From: Lauridsen, Keld B - DNR
Sent: Wednesday, March 16, 2022 7:07 PM
To: Langdon, Robert
Subject: RE: Former Appleby's Auto Salvage, W2578 Holland Lima Rd, Oostburg BRRTS No. 03-60-305128

Thanks for taking the time on March 11, 2022, to discuss the post-closure modification issues at the above site. DNR comments to your meeting notes are provided below in **red**.

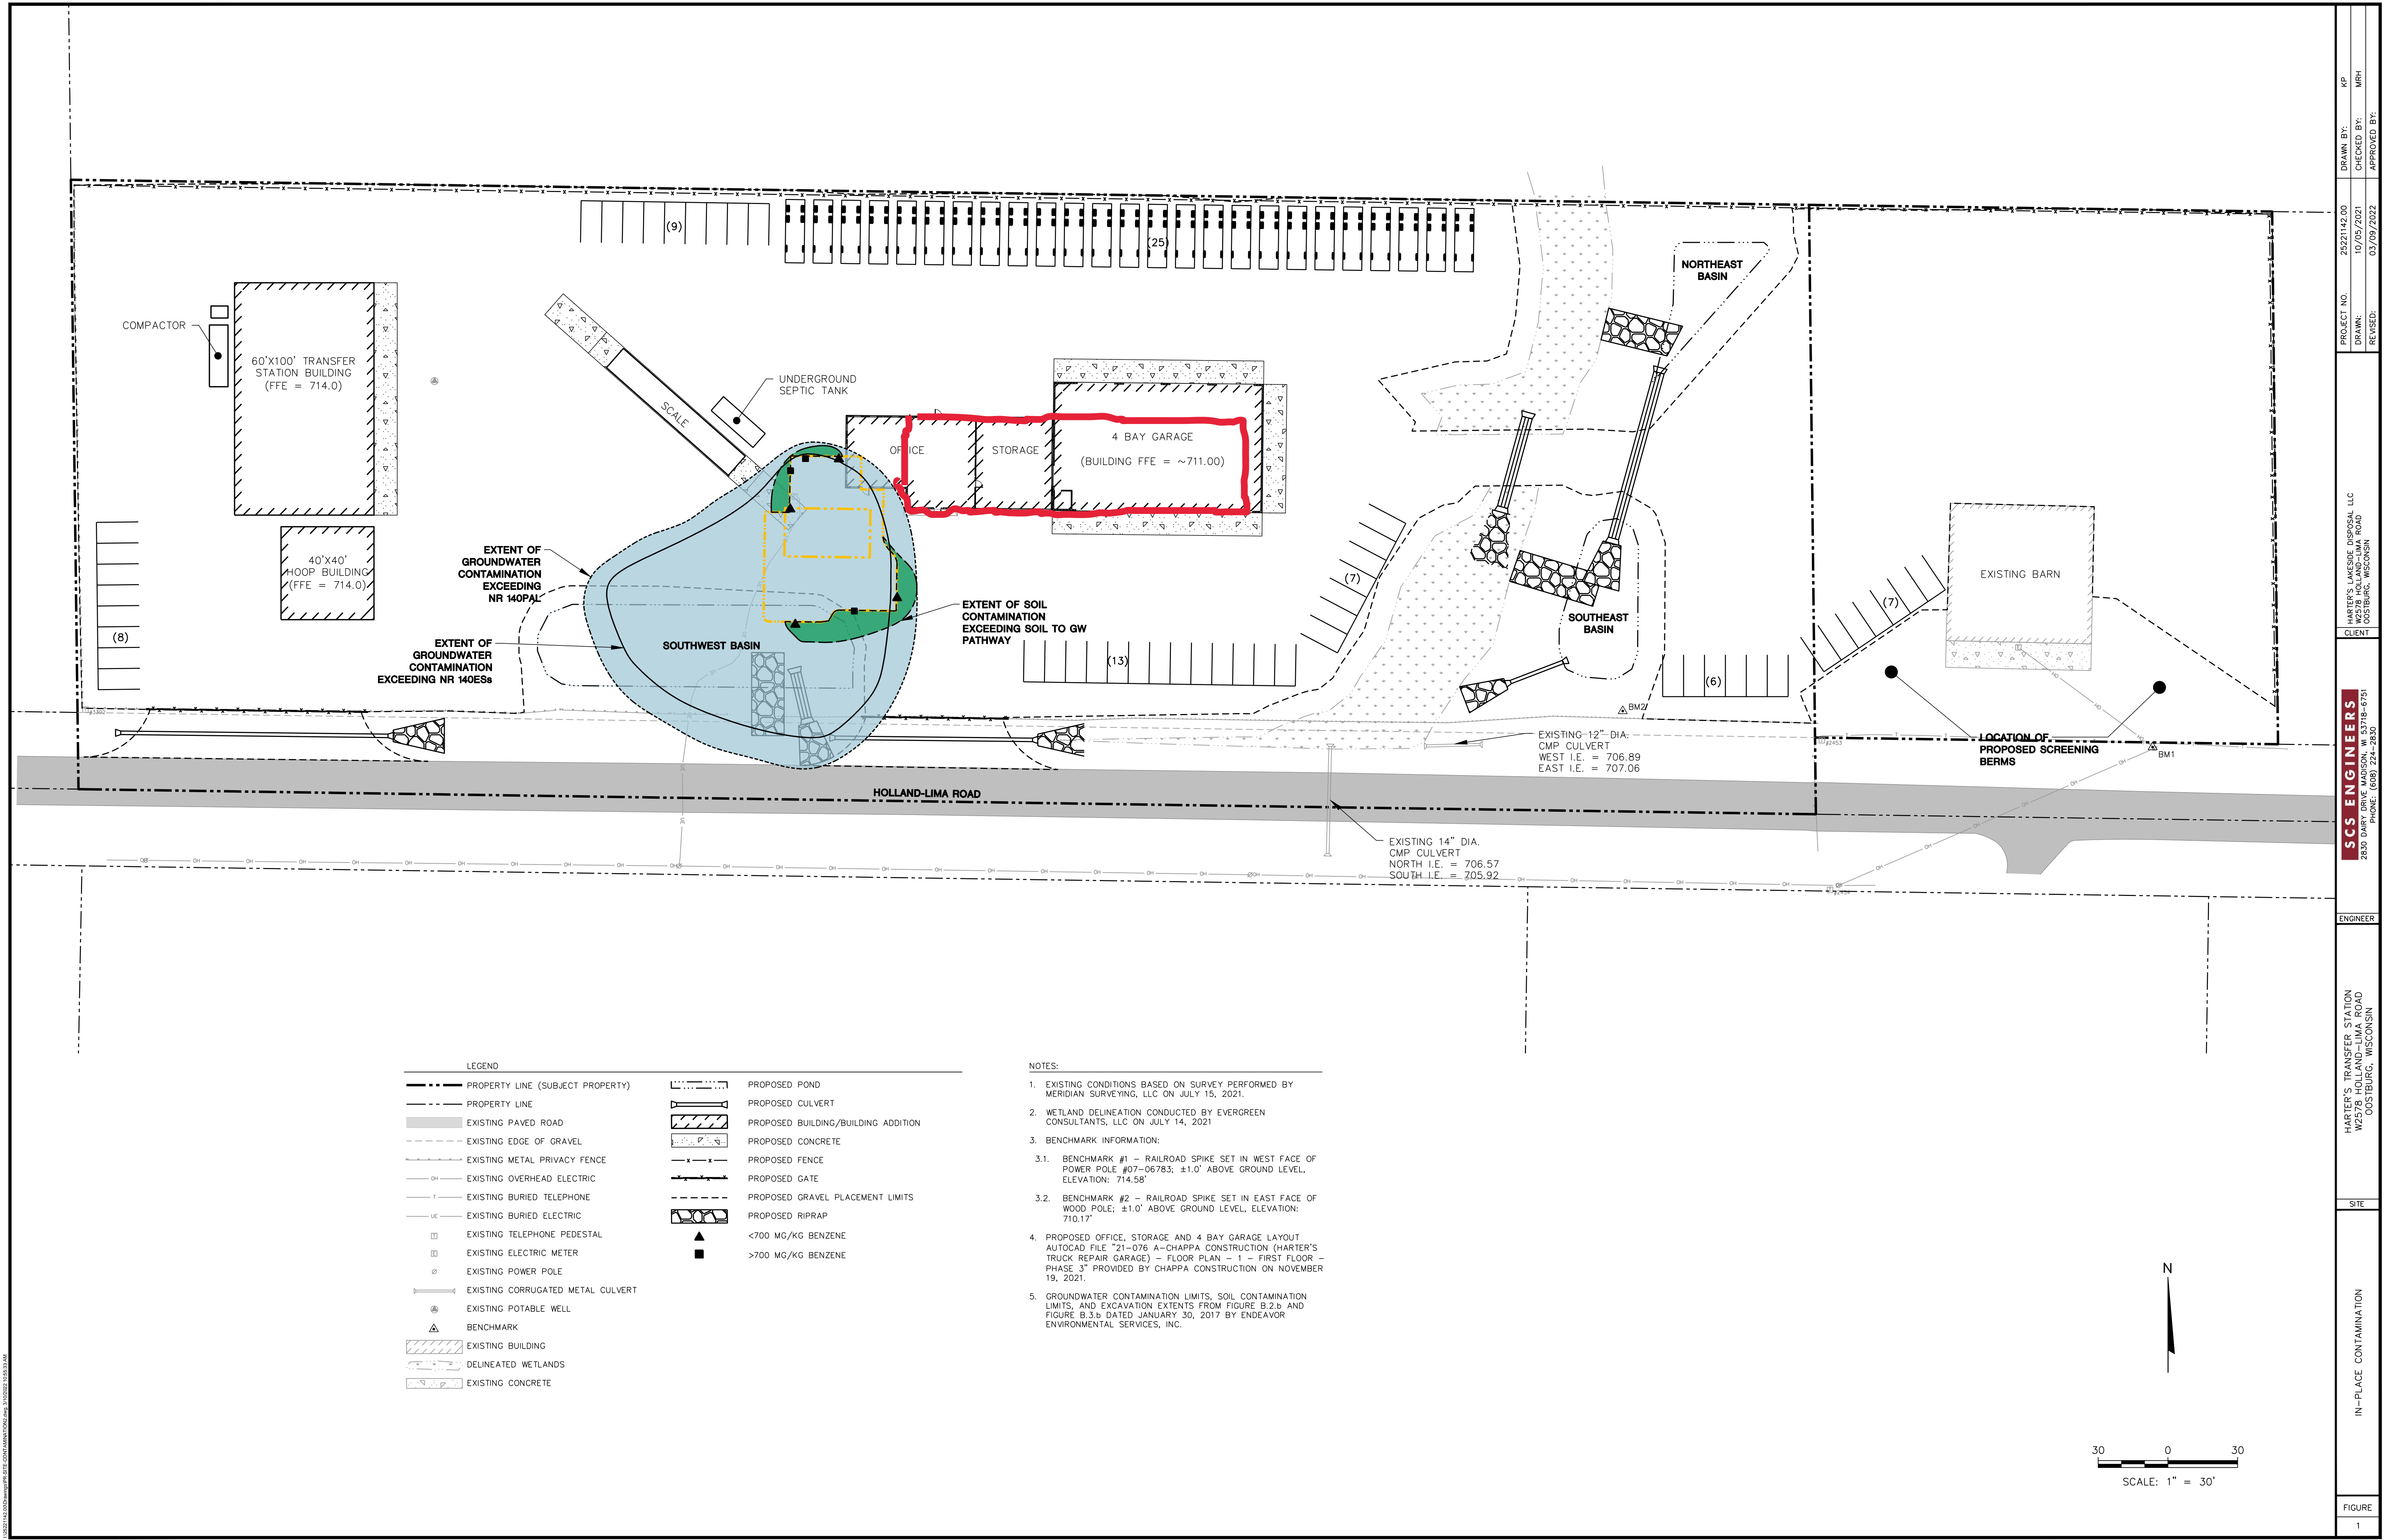
- Petroleum-contaminated soil will likely be generated during construction of a sedimentation basin, scale footing, and general grading within an area of soil contamination as shown on the attached figure. **It is assumed that a liner or clay barrier will be part of the sedimentation basin construction plans in order to limit contaminant leaching and provide for groundwater contaminant plume stability.**

- The owner would like to manage the contaminated soil on site and had indicated a desire to use it for screening berms on their adjoining property to the east as shown on attached figure. This property is outside the contaminated site boundaries. **Clean soil can be used as part of berm construction. The generator can make the waste determination and segregate non-impacted material during construction. Soil sampling completed prior to excavation activities could provide helpful information in order to potentially segregate any clean soil.**

- SCS planned to collect sub-slab samples within the existing building footprint to evaluate the potential for vapor intrusion since it appears that the proposed expansion of the building to the west would “screen in.” The approximate footprint of the existing building is shown with a red line on the attached figure.

- The sub-slab samples would be collected at the southwest corner of the existing building since this area is closest to residual soil and groundwater contamination and the proposed building expansion. **A brief work plan for the VI work is recommended to be prepared for DNR review.**
